February 22, 1980

RE: Oak Cliff Estates - Drainage Concept
 PEC File No. 30-79283-1120

Subject: Oakcliff Estates

Gen comments

TYPICAL SECTION

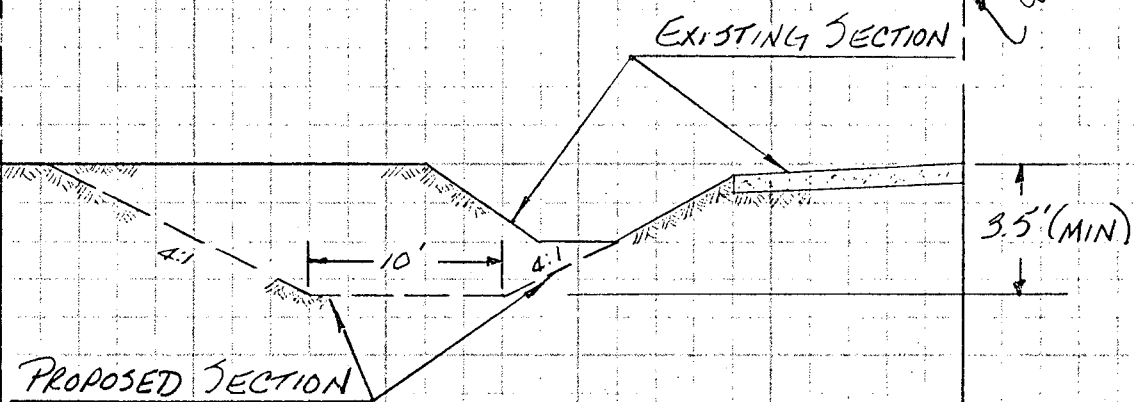
300 TO 400	62.3 CFS
400 TO 300	$62.3 + 34.6 = 96.9$ CFS
300 TO 200	$96.9 + 12.9 = 109.8$ CFS
200 TO CRC	$109.8 + 32.6 = 142.4$ CFS
